Premise Australia Pty Ltd

RESPONSE TO REQUEST FOR ADDITIONAL INFORMATION 2 – DA 240159

Premise have prepared this letter on behalf of ACEnergy Pty Ltd to respond to a request for additional information (RFI) issued by Yass Valley Council on the 18th of February 2025. The request is made in respect of development application reference number 240159 and relates to the proposed development of Murrumbateman Distribution Battery Energy Storage System at a site addressed as 3 Turton Place, Murrumbateman.

SECURITY FENCE AND TWO ROWS OF LANDSCAPE SIDE VIEW

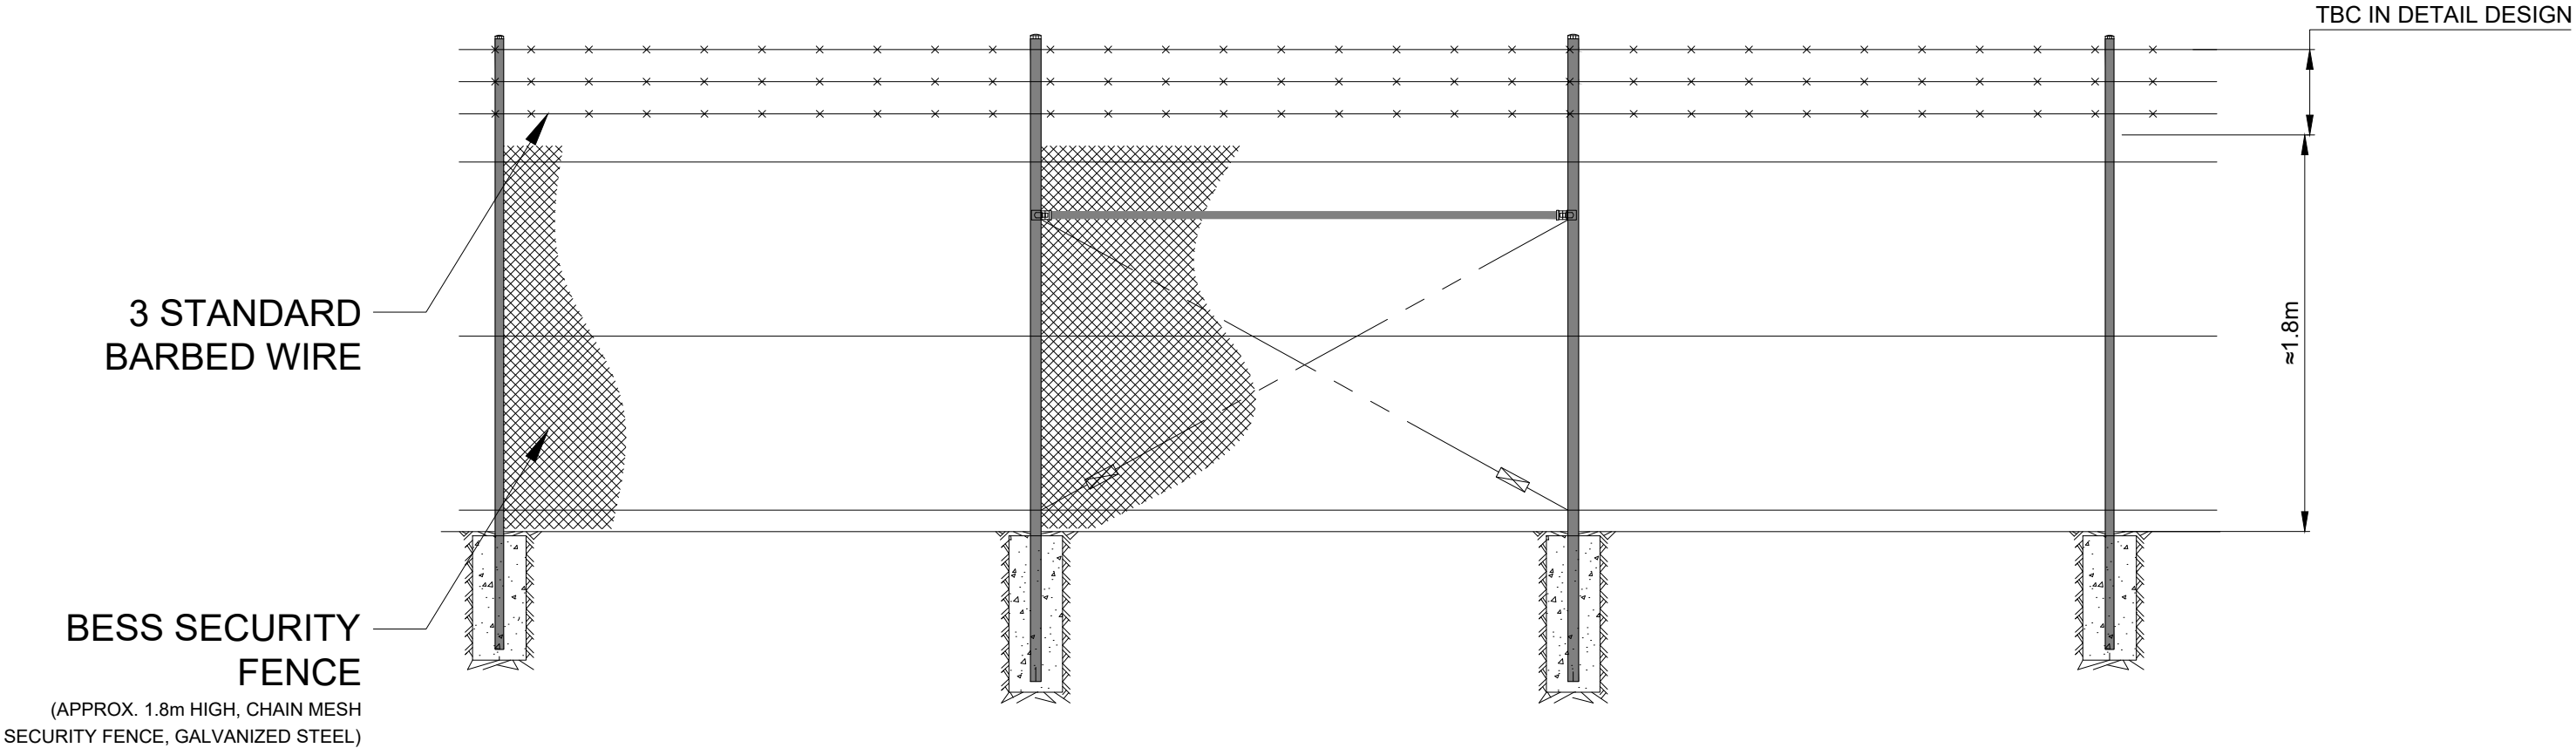
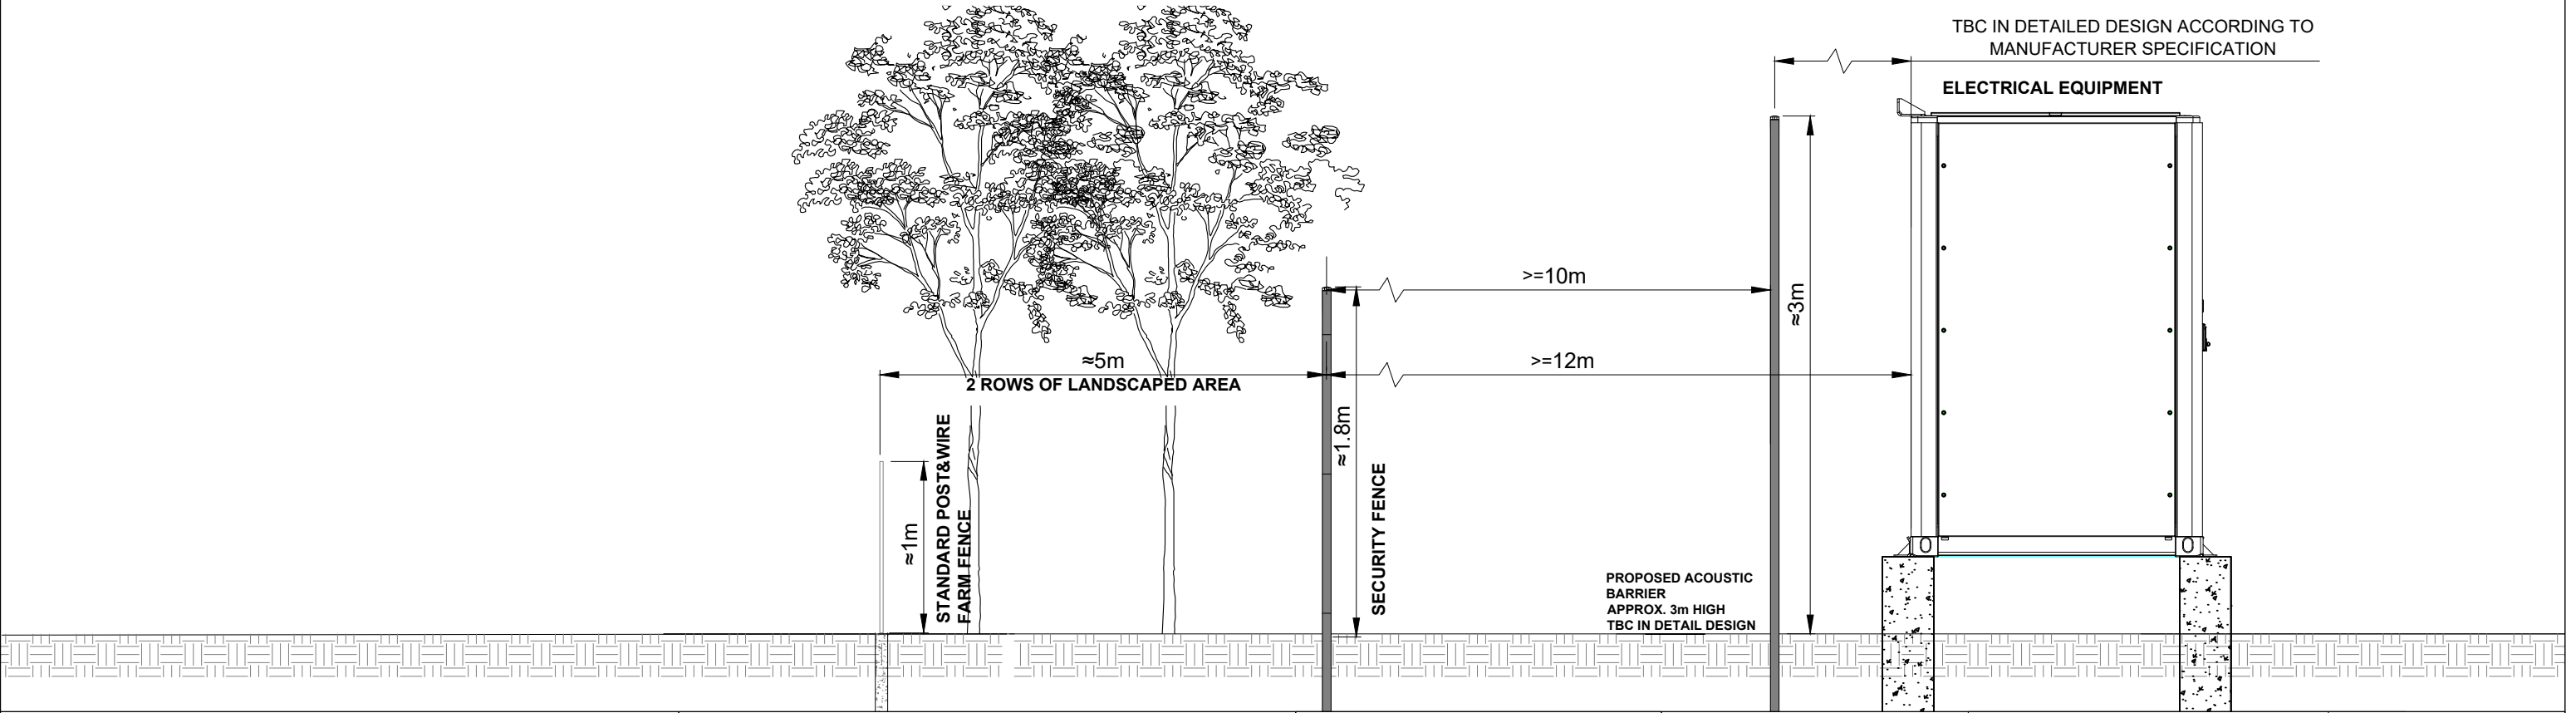
Additional Information Requested	Comments
<ul style="list-style-type: none"> • <i>Such that supports reducing the visual presence within the landscape.</i> 	
<p>4. Bushfire</p> <p><i>Advice received from the NSW Rural Fire Service (RFS) generally supported the assessment and recommendations made in the Bushfire and Emergency Evacuation Plan submitted with the application, with the exception that a 12m wide asset protection zone (APZ) is to be maintained to the west. A revised or supplementary site plan demonstrating that this can be achieved within the boundaries of the subject land is to be provided. The revised site plan is to also show the location of landscaping in relation to the APZ.</i></p> <p><i>It is noted in the record of briefing with the Panel that Council needs to consider how the APZ and landscaping requirements can coexist. It is recommended that a statement from the accredited bushfire practitioner is provided which confirms that the proposed landscaping per the landscaping plan is consistent with the assessment and recommendations made in their Bushfire and Emergency Evacuation Plan.</i></p>	<p>A revised drawing set (Attachment 2) includes an updated site plan to respond to council's request. The updated site plan details:</p> <ul style="list-style-type: none"> • The provision of a minimum 12 m wide APZ to the west of the BESS; and, • The location of landscaping in relation to the proposed APZ. <p>A revised Bushfire Assessment report has been prepared in consideration of the updated site plan and is provided as Attachment 4.</p> <p>As shown in the revised drawings the proposed landscaping area is situated outside of the APZ surrounding the BESS. The revised Bushfire Assessment details that the APZ is located wholly in grassland, with no trees within the development footprint and that grass within the APZ should be kept mown (<100mm in height).</p> <p>It should be noted that Section A1.10 of PBP outlines that certain types of vegetation are classified as low threat vegetation. This includes:</p> <p><i>"grassland managed in a minimal fuel condition, mangroves and other saline wetlands, maintained lawns, golf courses such as playing areas and fairways, maintained public reserves and parklands, sporting fields, vineyards, orchards, banana plantations, market gardens and other non-curing crops, cultivated gardens, arboretums, commercial nurseries, nature strips and windbreaks.</i></p> <p><i>Note: 1. Minimal fuel condition means there is insufficient fuel available to significantly increase the severity of the bush fire attack (recognizable as short cropped grass for example, to a nominal height of 100 mm). 2. A windbreak is considered a single row of planted trees located on a boundary and used as a screen or to reduce the effect of wind on the leeward side of the trees."</i></p> <p>Low threat vegetation is excluded from <i>Australian Standard- Construction of buildings in bushfire-prone areas (AS 3959 2009)</i> and is not required to be considered for the purposes of PBP.</p> <p>A statement from the bushfire consultant, nevertheless, has been prepared by the bushfire consultant to respond to Council's request and is provided as Appendix 5. The statement</p>

Figure 4: Proposed acoustic barrier arrangement

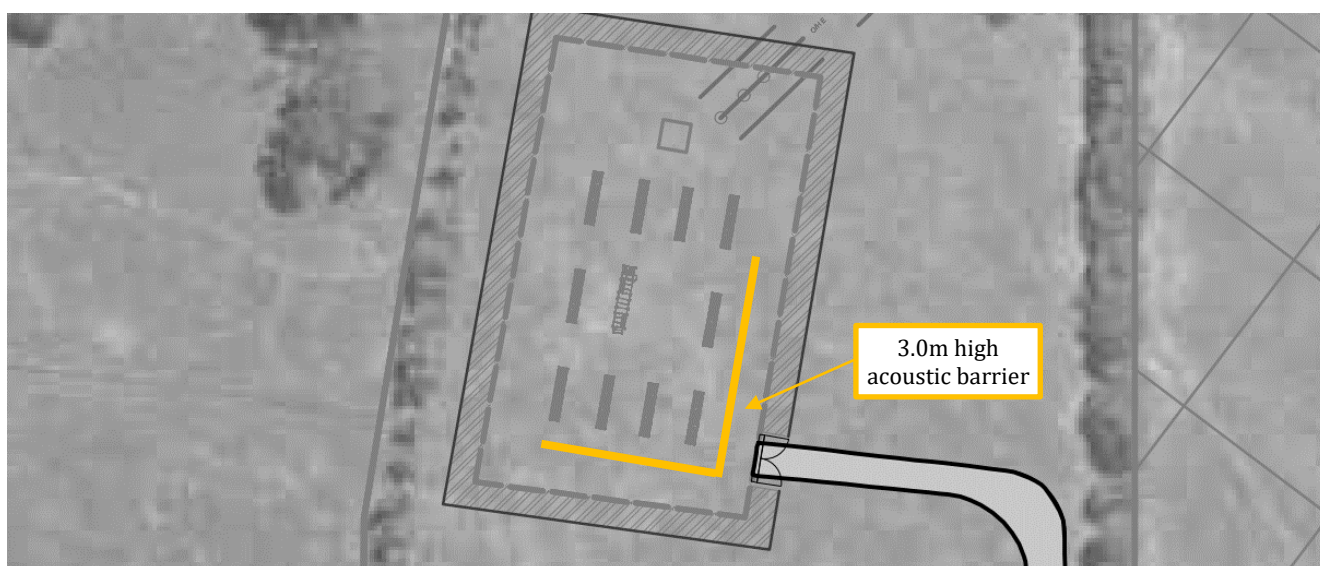
Due to the predicted non-compliances, WMG has amended the noise model to include a 3.0m high acoustic barrier to the east and south of the electrical infrastructure which will provide noise shielding in the direction of these receptors.

Based on the results of the noise model the acoustic barrier will need to be constructed to be 3000mm high and located to the south and east of the equipment to provide sufficient noise shielding in the direction of the nearby receptors.
